DCCBNA Recall Bulletin

Exhaust Elbow Failures

Subject: SAFETY DEFECT – Exhaust Elbow 070774434

Models: Orion VII

Figure 1-2 Exhaust Elbow Welds

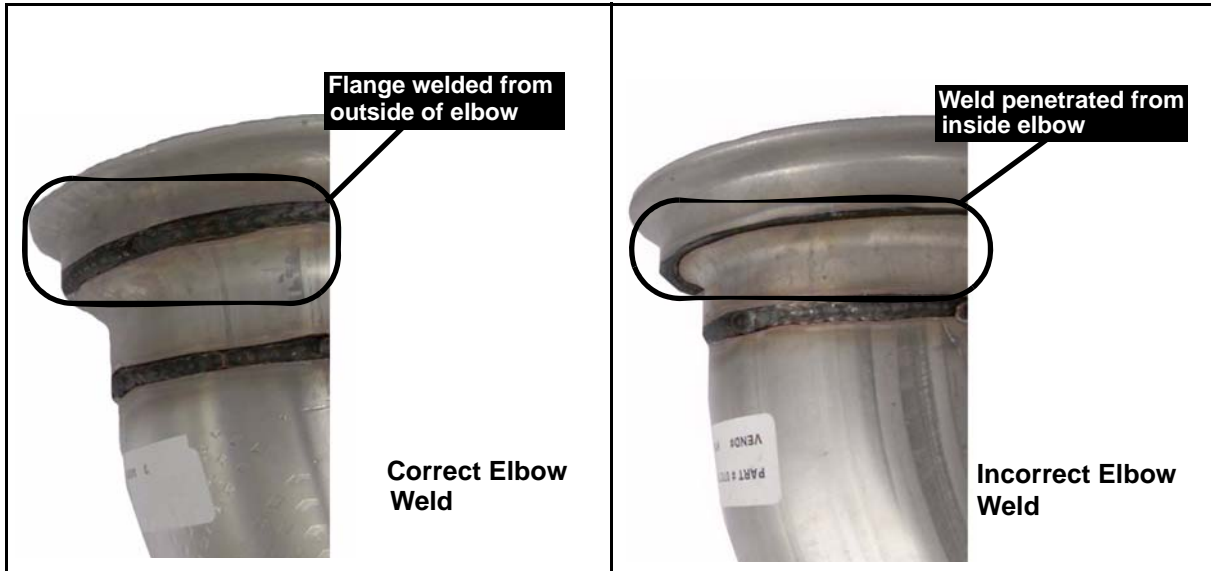
Defect: A weld on an exhaust elbow, part number 070774434, was incorrectly manufactured.

5. Inspect exhaust elbow for correct welds. [See Figure 1-2](#)
 - a. If welds are found to be incorrect, exhaust elbow must be replaced. [See "Procedure" on page 4.](#)
 - b. If welds are found to be correct, no procedure needed, secure exhaust blanket clips, close engine compartment access door and turn battery isolator switch to the ON position.

1. Install new exhaust elbow **070774434** at the exhaust flex pipe.
2. Secure the two exhaust elbow v-clamps.
3. Close the engine compartment access door.
4. Secure exhaust blanket clips.
5. Turn battery isolator switch to the ON position.
